## Reelmaster® 6500/6700-D

Subject: Rear two Cutting Units (under-engine) Raise and Lower Too Fast.

Ref: 15-07 Copyright<sup>®</sup>, 2001. The Toro Company

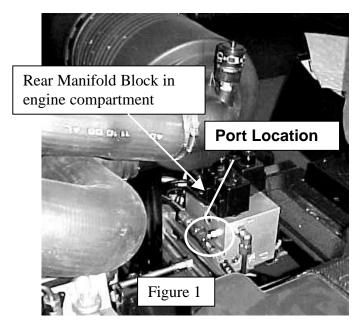
**Note:** The Port is marked **C3B on RM 6500**, and **C2B on RM6700** (Fig. 1).

A screw-in, fixed (non-adjustable) Orifice (94-2626) can be installed into the rear Manifold Block that will reduce the raise/lower rate of the 2 under-engine cutting units.

To install, turn on key and lower the cutting units to the ground. Remove the 2 hydraulic hoses and Tee Fitting at the rear Manifold Block as shown in Figure 2. Install Orifice (Fig. 3) using a 1/8" Hex wrench. Re-install the Tee Fitting and hoses.

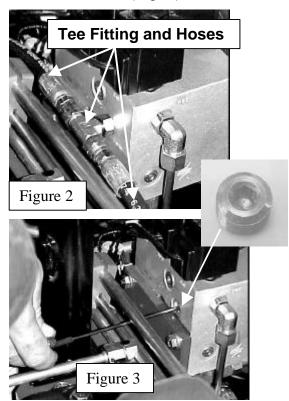
Beginning with the 2000 model year product, the cutting unit hydraulic lift system was changed from a series system to a parallel system. Since parallel systems split oil flow and reduce the speed of lift and lower, the control orifice was removed from this circuit. Because of these changes, some tractors may seem to raise the two rear "underengine" cutting units (#2 & #3) too fast and hit the tractor frame abruptly.
